MIL-F-50983B (AR)
AMENDMENT 8
22 February 1984
SUPERSEDING
AMENDMENT 7
6 June 1983

MILITARY SPECIFICATION

FUZE, MT, SQ, M577
LOADING, ASSEMBLING, PACKING AND METAL PARTS
FUZE, MT, SQ, M582 METAL PARTS

This amendment forms a part of Military Specification MIL-F-50983B (AR), dated 30 June 1980, and is approved for use by the US Army Armament, Munitions and Chemical Command and is available for use by all Departments and Agencies of the Department of Defense.

FIGURE 1

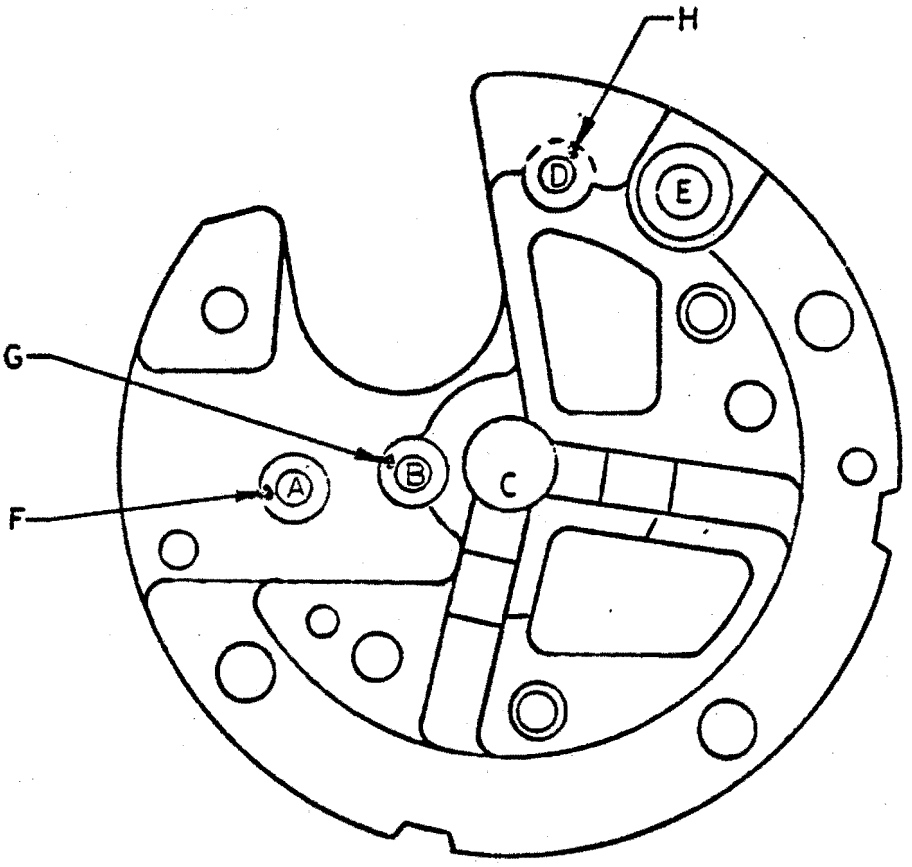
* 3.17.2: Delete "Figures 5 and 6" and substitute "Figures 1 and 2".

Add Figures 1 and 2 attached.

FEATURE	MAX SINGLE PORE SIZE IN ANY DIRECTION (IN.)	MIN REMAINING IDEAL SURFACE (%)
HOLE A	.02	90
HOLE B	.02	90
HOLE C	.10	80
HOLE D	.02	90
HOLE E	.10	80
SURFACE F	.02	80
SURFACE G	.02	80
SURFACE H	.02	80
